Pine Crest Elementary School Addition, Mandatory Referral, MR2019005

Completed: 12-12-18

Mandatory Referral to construct a two-story classroom addition, multi-purpose room expansion, and additional parking, with associated stormwater management.

RE: Mandatory Referral Letter
Mandatory Referral No. MR2019005
Pine Crest Elementary School Addition

Figure 3: Proposed Site Plan

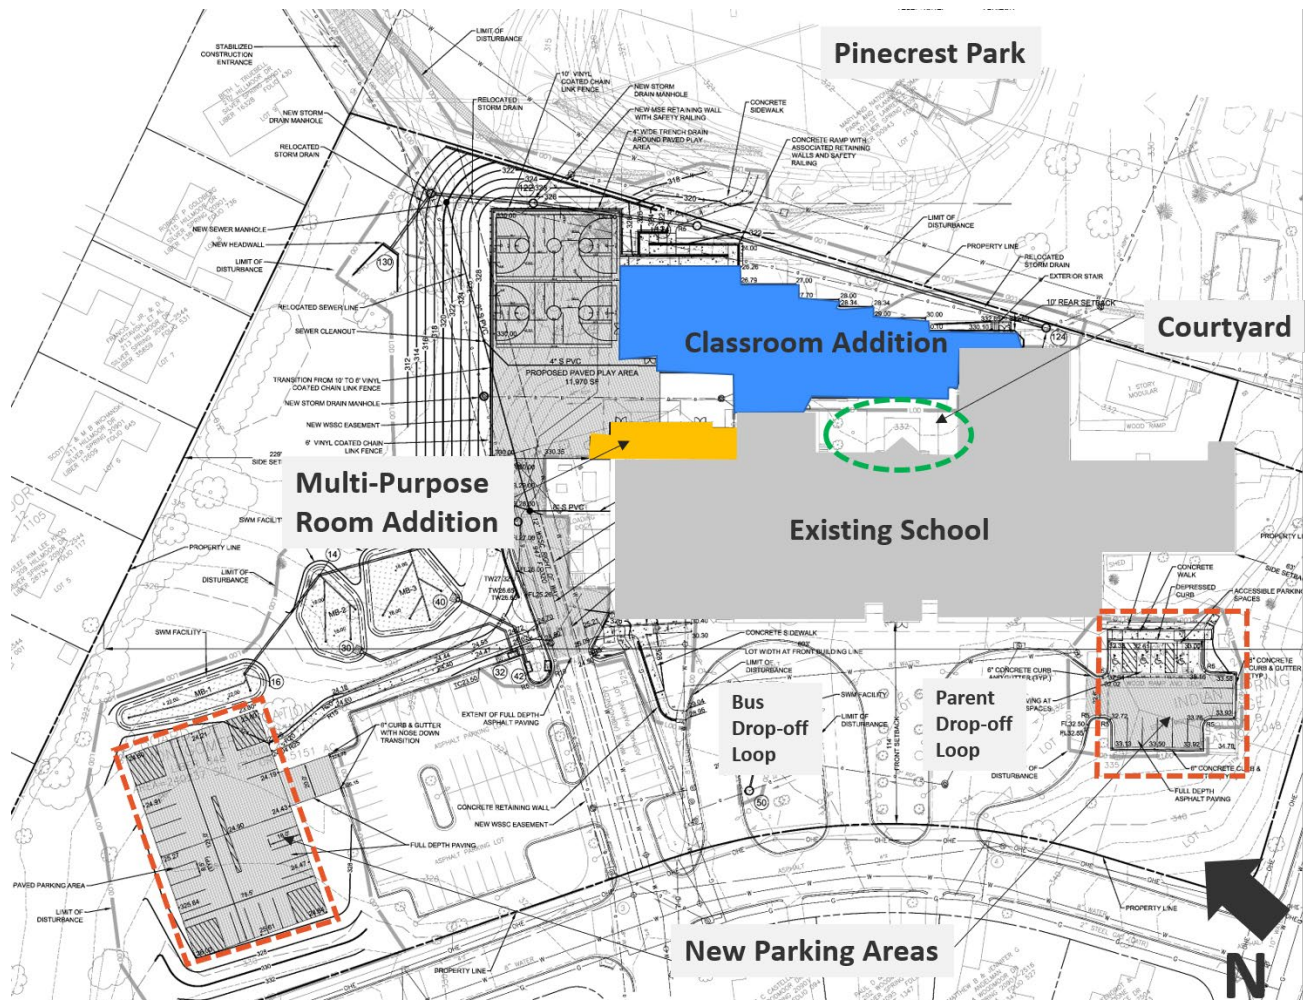
1. MCPS should explore ways to increase the efficiency of the proposed additional parking areas, including the layout for the parent drop-off loop proposed by the Montgomery County Department of Transportation (MCDOT).

There are two areas of additional parking proposed, to the east and west. The western parking area is connected to existing parking by a connecting drive aisle. This design could be more efficient through the elimination of the connector and creating a seamless continuation of the existing parking. The eastern parking can be redesigned to create a larger parent drop-off loop, as proposed by Montgomery County Department of Transportation (MCDOT) (Attachment 3). MCDOT has proposed an extended parent drop-off loop with parking stacked in the interior, as shown in Figure 4. This proposal creates additional parent drop-off queuing and maintains a comparable number of spaces.

SITE PLAN

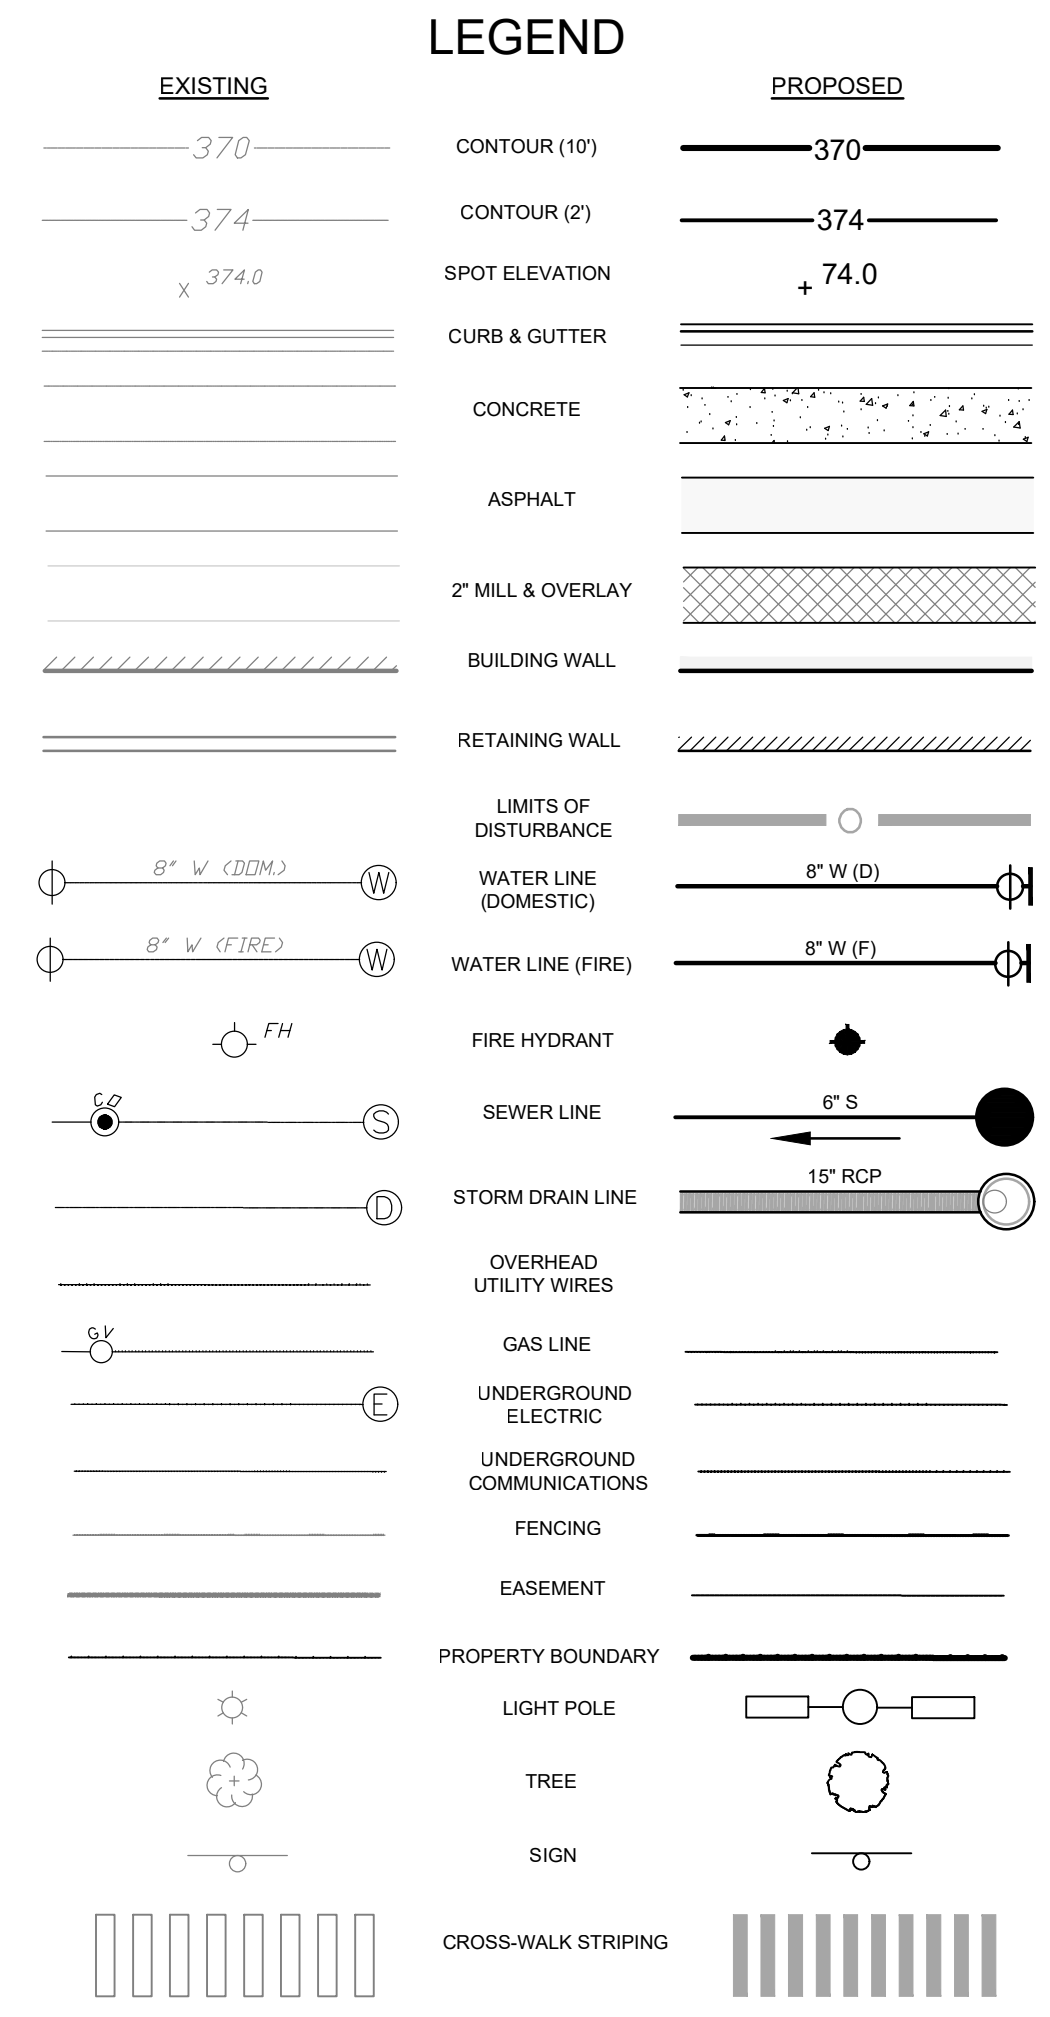
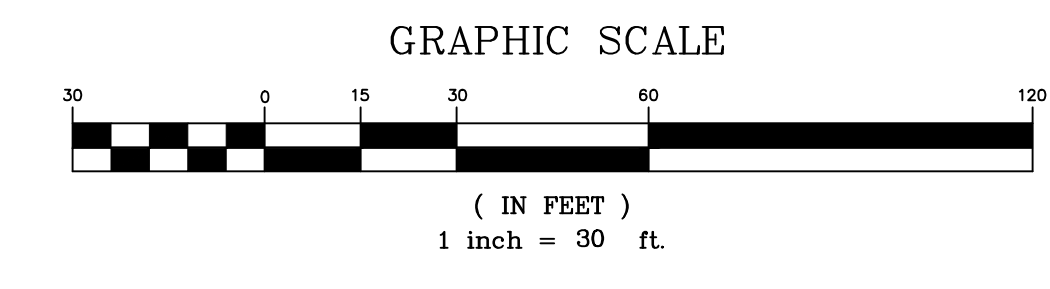
2. The plan should show the following:
 - a) The right-of-way width of Woodmoor Drive and St Lawrence Drive.
 - b) Label the roadways along the site frontage.

Attachment (1): Concept sketch reconfiguring the parent loop and proposed parking

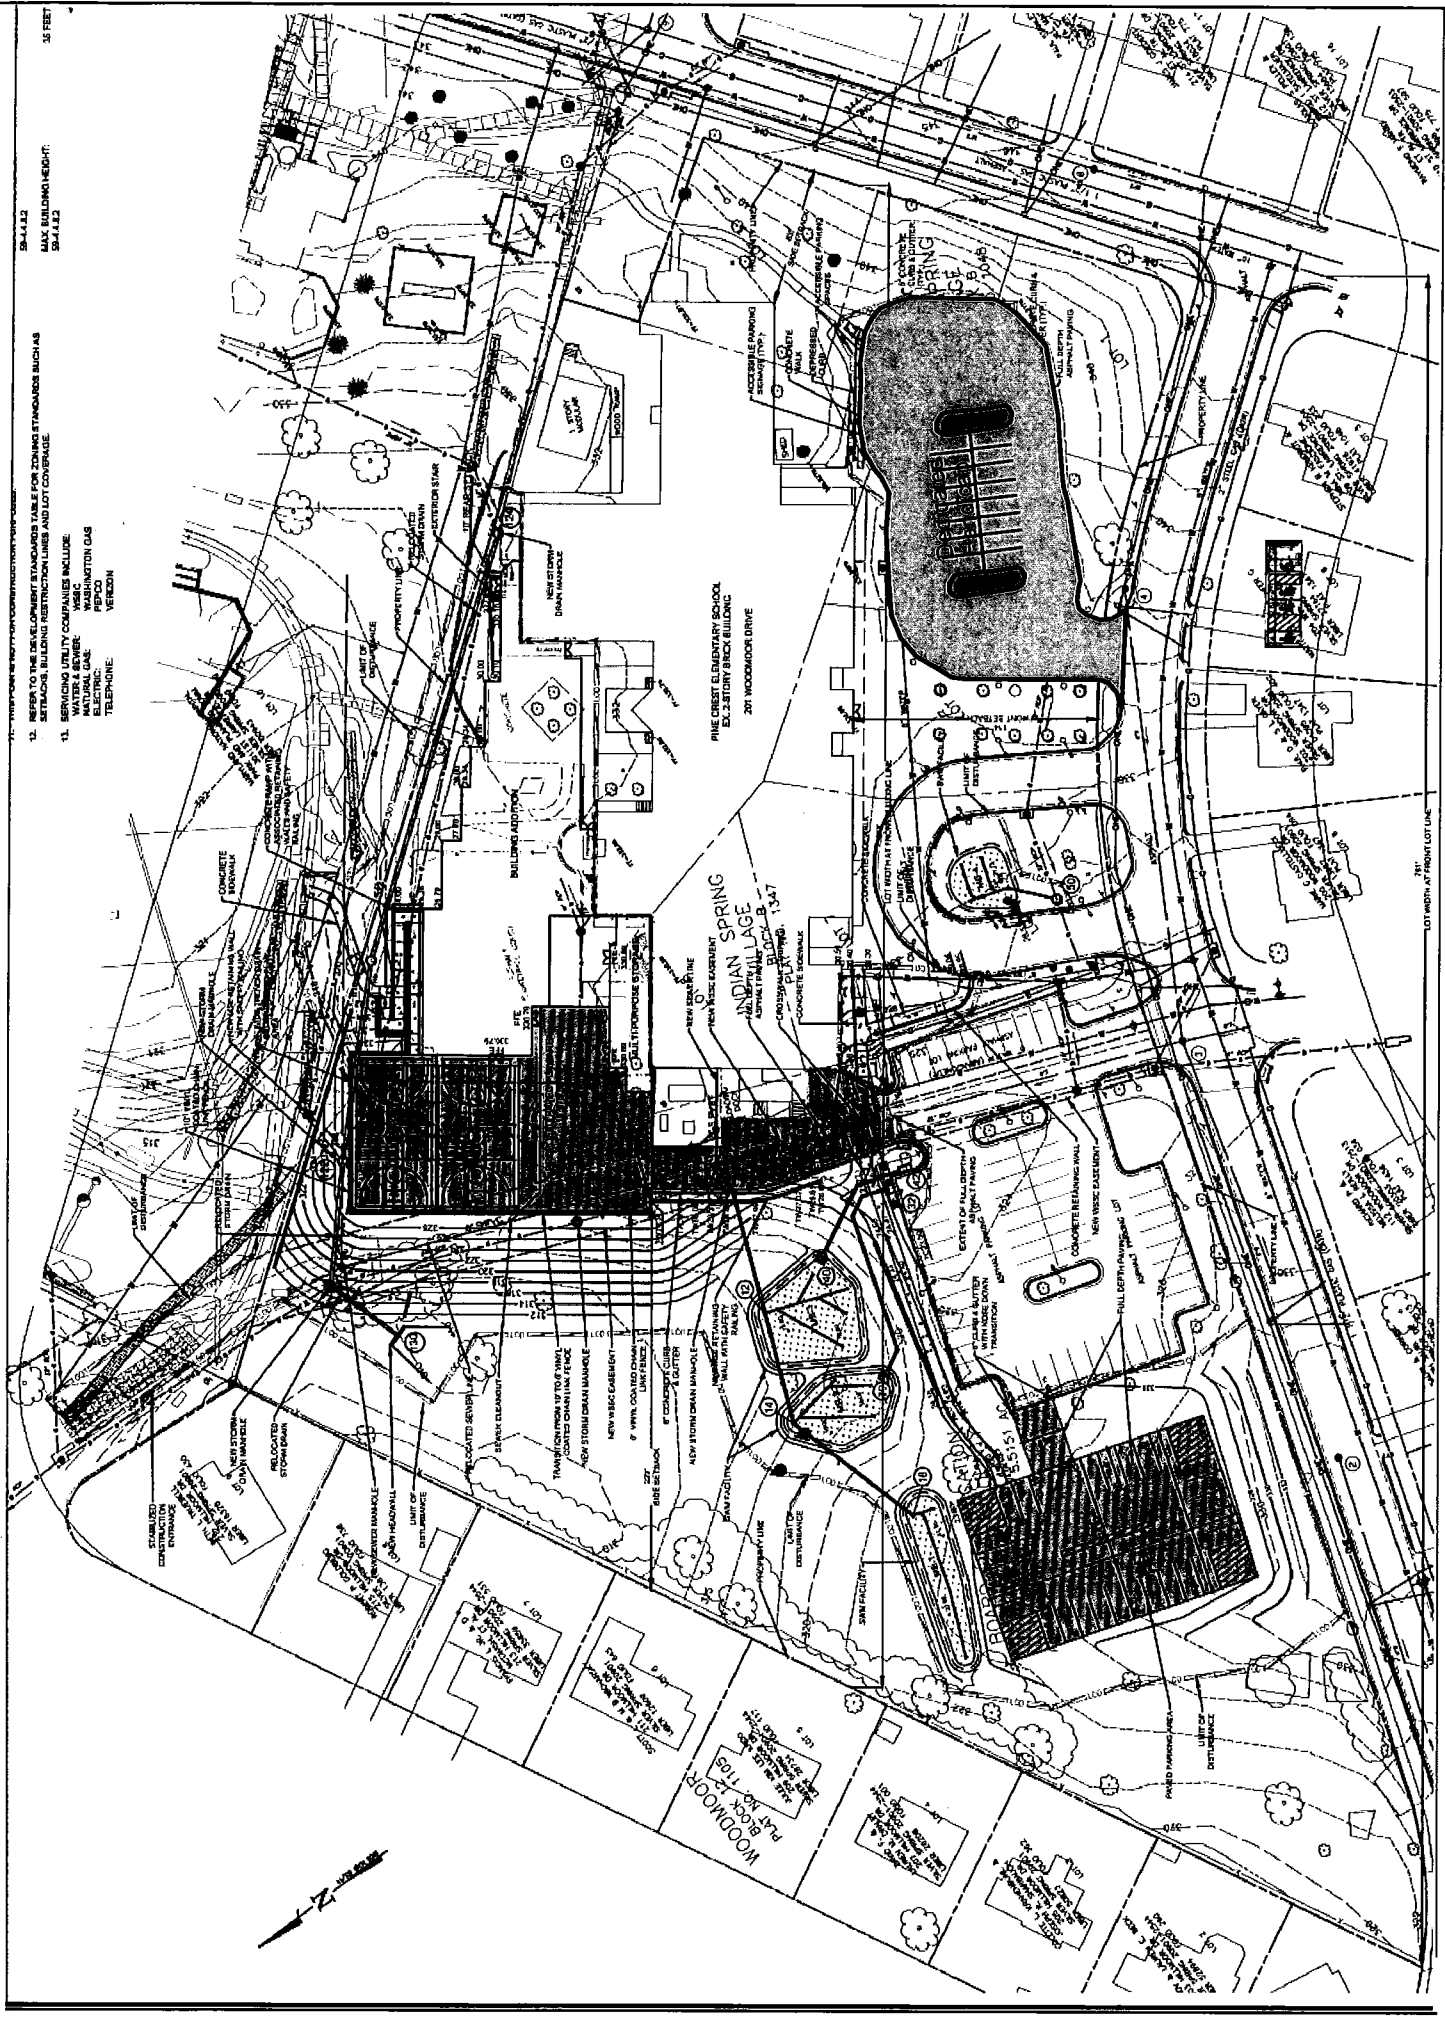
1. We recommend the following:
 - a) The applicant should consider/evaluate increasing the size of the parent drop-off loop due to the addition of 165 new students. Please see attached a concept sketch reconfiguring the parent loop and the proposed parking.
